100 GROVE ST. | WORCESTER, MA 01605

June 19, 2020

**Subject: 80 Snow Road, Lot 2 and Lot 3
Special Permit, Site Plan and Stormwater Review**

Driver's sight line looking west from the proposed Lot 2 driveway entrance.

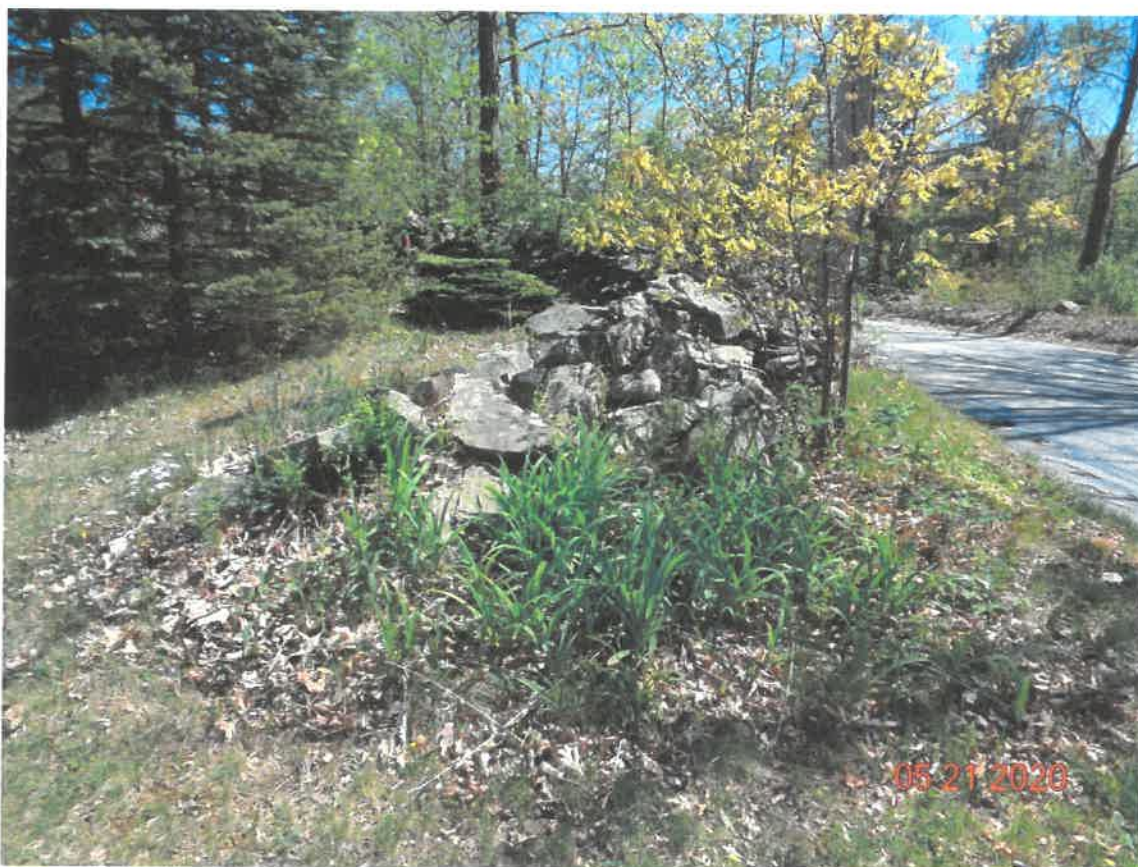
14. Sight lines at the driveway entrance are unacceptable and need to be addressed. The area between the two driveways (including the shoulder of Snow Road) needs to be excavated and re-graded to provide sight lines appropriate for travelled speeds and grades on Snow Road as determined by the design engineer (no less than 30 mph). Such excavation could require that the existing utility pole would have to be reset deeper into the ground. Photos of the problematic sight lines are presented below.

15. The plans should note that brush clearing on the west side of the Lot 3 driveway needs to be performed to keep vegetation from obstructing sight lines to the west.
